## **REGIONAL TRANSPORTATION COMMISSION**

RE: PCN16004 (Copper Canyon Handbook Amend)

The applicant is requesting a tentative and final approval of an amendment to the Copper Canyon Planned Development Handbook to revise development standards to allow for a gas station use on 1,308 acre site which is located east of Vista Boulevard at Brierley Way.

TYPICAL 120' RIGHT-OF-WAY SECTION SIX TRAVEL LANES

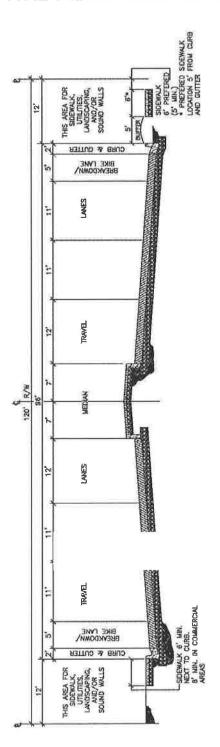
The 2035 RTP identifies Vista Boulevard from I-80 to Prater Way to be widened from 4 to 6 lanes by 2035. Dedication of right of way or setbacks adequate to complete RTP improvements should be required as a condition of approval. See the attached typical 120' right of way section for a 6 lane facility. Additional right of way may be required for dedication right turn lanes at intersections.
